Addendum #2: Cover Page

Project: Allen Bowden Public Schools – Activity Center

Addenda

Project: **Allen Bowden Activity Center**
Allen Bowden Public Schools

Subject: FW: Sapulpa Rural Waterlines

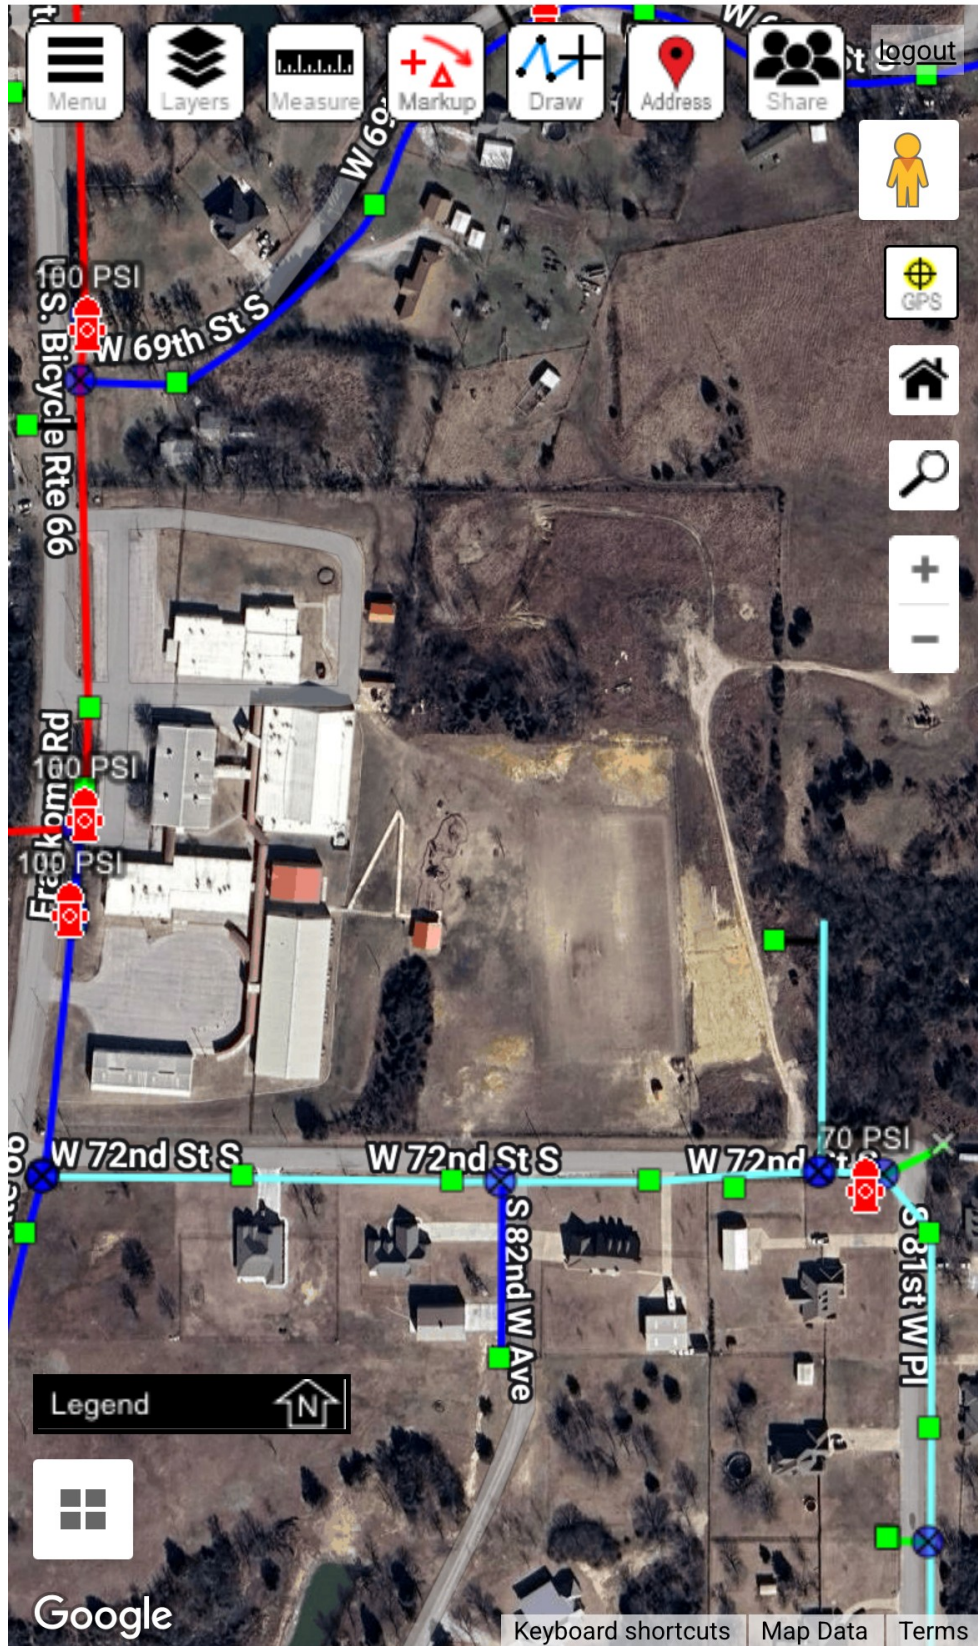
Please find attached a screenshot of where Sapulpa Rural's waterlines are located. There is 6-inch line on Frankoma Road and a 6-inch line on W. 72nd St. S. and a 10-inch line on the east side of the football field. The line on W. 72nd St. S. is on the south side of the street so it would require a road bore to take water to the north side of the street. If there are any questions, please contact us. Thank you.
